# Questions and Answers # 4

**Question #1: Category 6A - Item #3:**

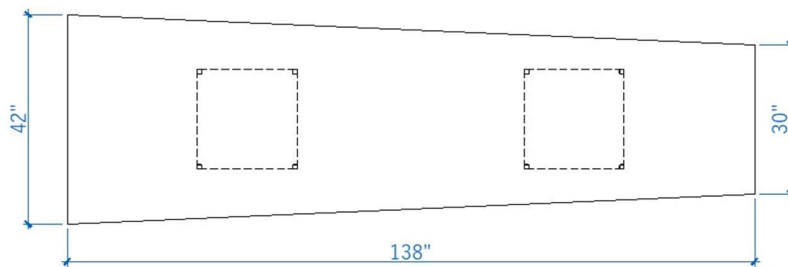
For video conference tables that are only 42" deep, a column base is not typically recommended as it reduces the leg room and seating space. (see sketch below). Would the client also accept an alternative base type of post legs (GoCUID 6MVCSNVSLL42138WYYX)?

The SA details list Panel Bases as an option in the description, but there is no GoCUID representing panel bases. Are Panel bases included within the Column Base GoCUID?

The client is not requesting a panel base support for the videoconferencing table. GoCUID 6MVCSNVSML42138WYYX that the client chose was taken from the GCWorkplace Standard Furniture Typicals as pictured below. We have updated the Description of the Product for this item under Subcategory 6A as per amendment 003. Please note that according to the specifications in the SA, the minimum overall width at the narrowest end for a video conferencing table is 42". The client also accepts an alternative base type of post legs however we still require V-shape, Modesty Panel and Power and Data.
